BIDDING AND CONTRACT REQUIREMENTS
ADDENDUM NUMBER 1

Date: February 11, 2025

Architect's Project Number:
224151.00

Re: **Addendum Number 1 to the bidding documents for:
Moline – Coal Valley School District #40
Browning Field Concessions and Toilet Room Improvements**

MECHANICAL ROOF HVAC
PLAN

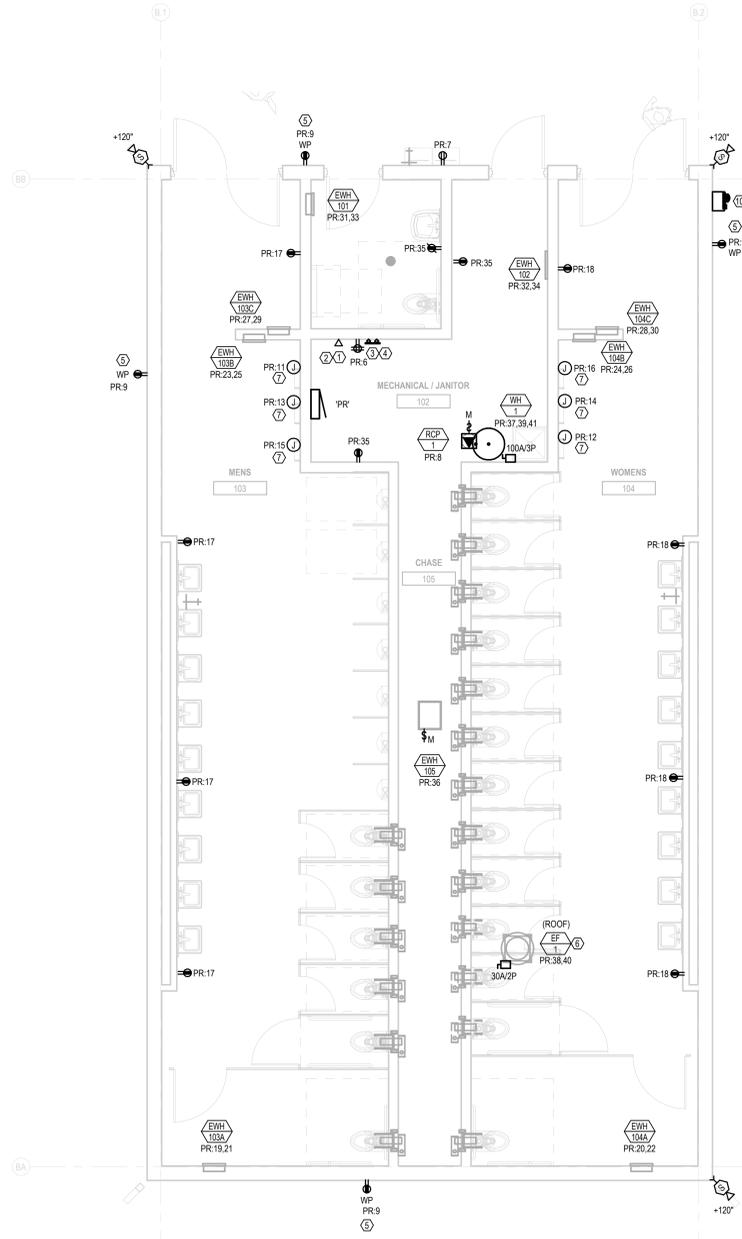
- R. Drawing M-102, titled, MECHANICAL ROOF HVAC PLAN.
 - 1. At KEYNOTES
 - 1) REVISE location to add clarity to drawings.
- S. Drawing E-101, titled, ELECTRICAL FIRST FLOOR POWER PLAN

2 ELECTRICAL FIRST FLOOR POWER PLAN - CONCESSIONS
E-101 1/4" = 1'-0"

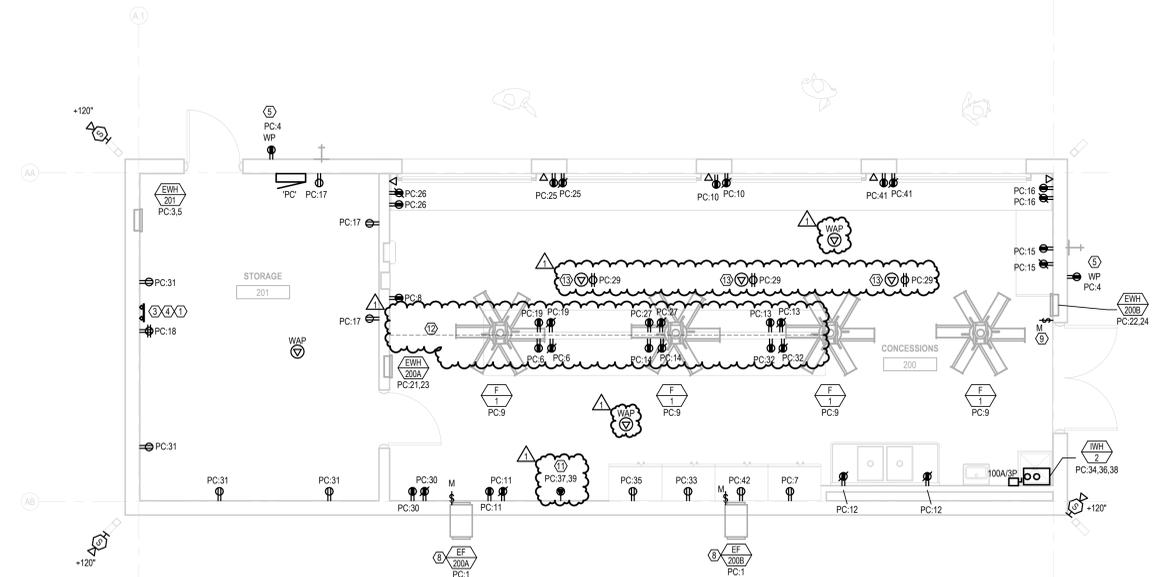
- 1. At CONCESSIONS 200
 - 1) ADD THREE CEILING DUPLEX RECEPTACLES
 - 2) ADD THREE CEILING DATA BOXES
 - 3) ADD SPECIAL OUTLET
 - 4) ADD DETAIL FLOOR CONDUIT PATH LINE

- 5) ADD KEYNOTES 11, 12, & 13
 - 6) REVISE WAP CEILING MOUNTED LOCATION
- T. Drawing E-301, titled, ELECTRICAL ONE LINE DIAGRAM, DETAILS, AND SCHEDULES
